**SUNDRY NOTICES AND REPORTS ON WELLS**  
*Do not use this form for proposals to drill or to re-enter an abandoned well. Use Form 3160-3 (APD) for such proposals.*

**Sand Tank 17 5H**

**Sand Tank 17 Fed Com 5H  
30-015-39671  
EOG Resources Inc.  
January 7, 2012  
Conditions of Approval**

**EOG Resources  
Cactus #123  
Exhibit #1a**

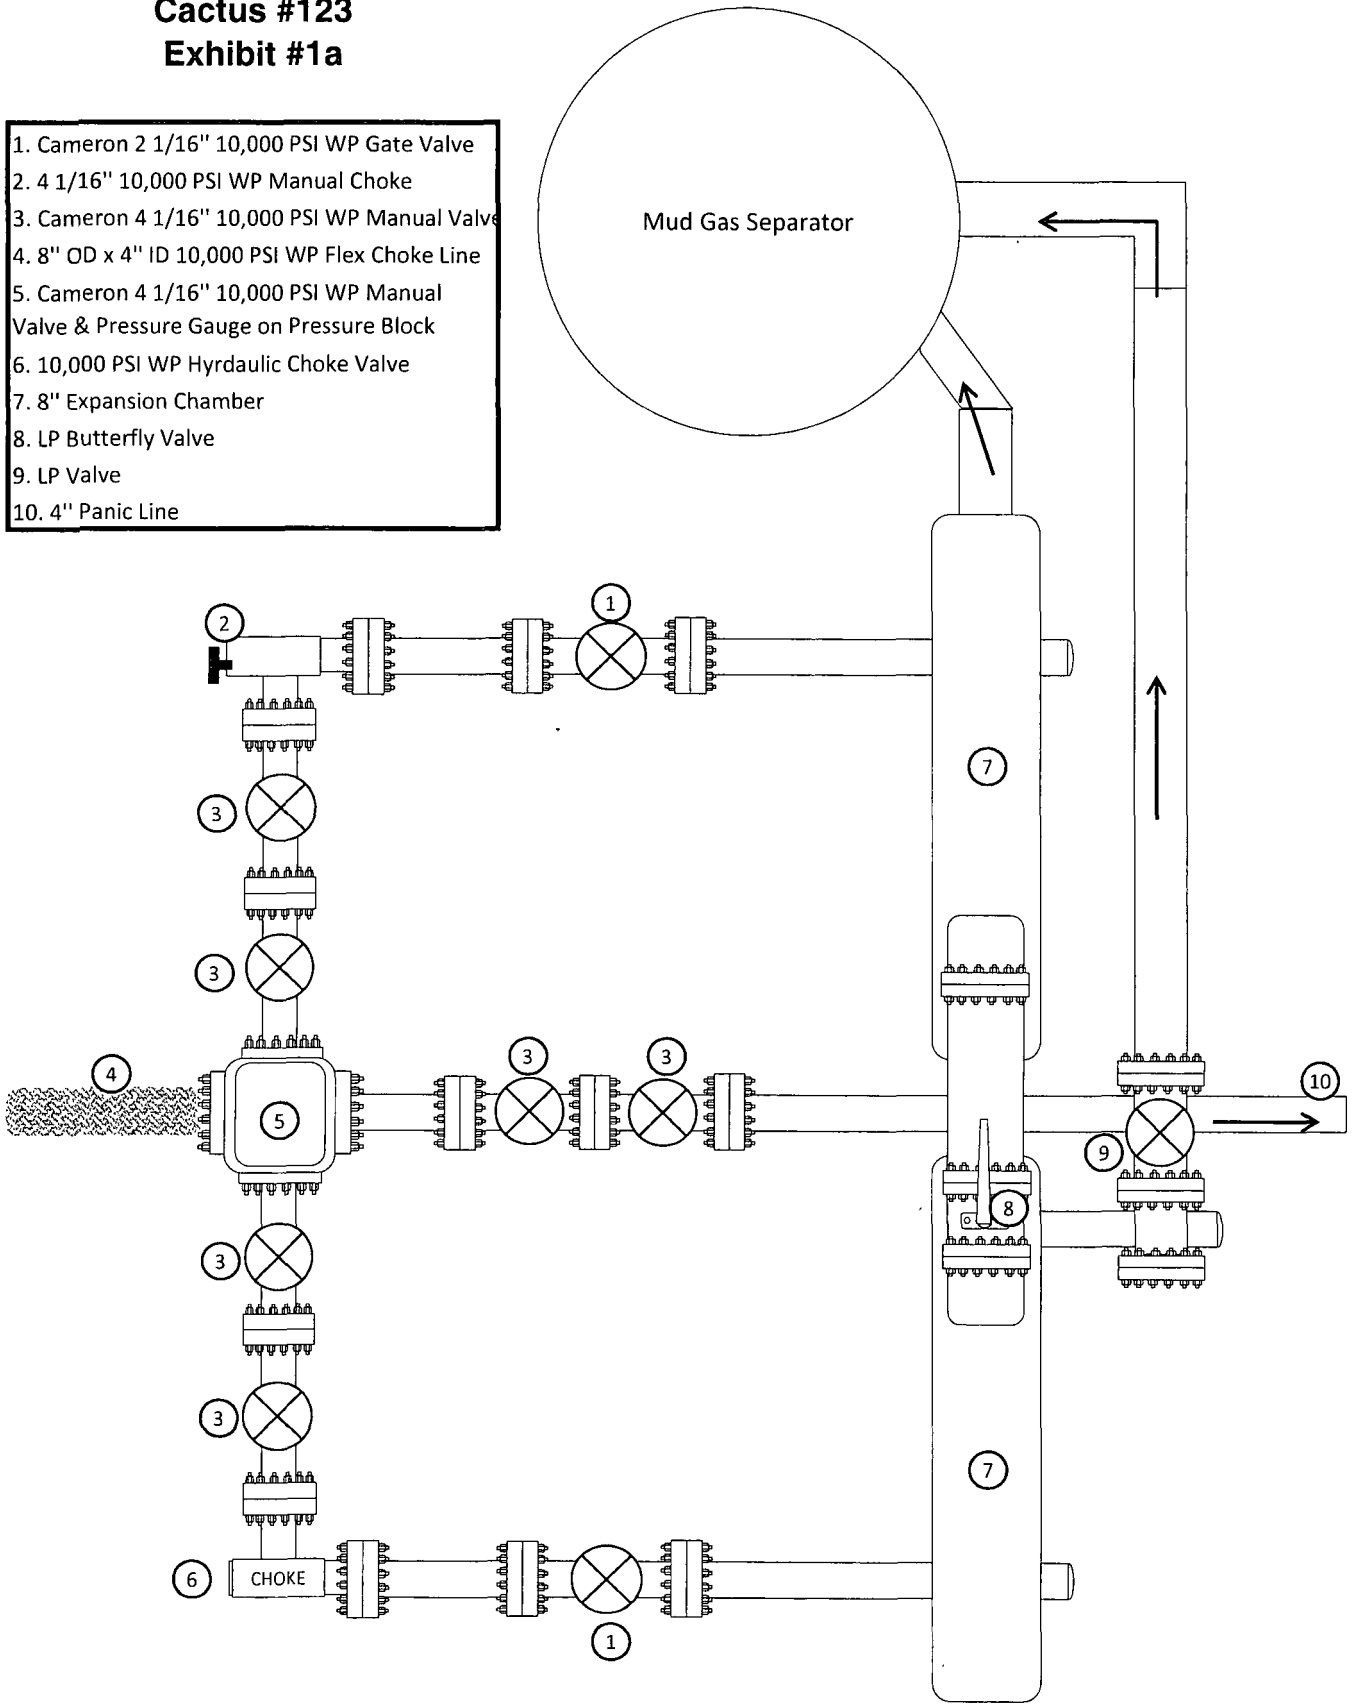
**EOG Resources requests a variance to drill this well using a co-flex line between the BOP and the choke manifold (instead of using a 4" OD steel line). Also amending BOPE as attached.**

1. Cameron 2 1/16" 10,000 PSI WP Gate Valve
2. 4 1/16" 10,000 PSI WP Manual Choke
3. Cameron 4 1/16" 10,000 PSI WP Manual Valve
4. 8" OD x 4" ID 10,000 PSI WP Flex Choke Line
5. Cameron 4 1/16" 10,000 PSI WP Manual Valve & Pressure Gauge on Pressure Block
6. 10,000 PSI WP Hyrdaulic Choke Valve
7. 8" Expansion Chamber
8. LP Butterfly Valve
9. LP Valve
10. 4" Panic Line

- 1. Variance approved to use flex line with Serial #90067 from BOP to choke manifold. Check condition of 4" flexible line from BOP to choke manifold, replace if exterior is damaged or if line fails test. Line to be as straight as possible with no hard bends. If the BLM inspector questions the straightness of the hose, a BLM engineer will be contacted and will review in the field or via picture supplied by inspector to determine if changes are required (operator shall expect delays if this occurs).**
- 2. Profile and aerial view of manifold to closed loop system are still in effect since new schematics do not show that piping.**
- 3. BOP/BOPE to be tested as approved in original Conditions of Approval.**
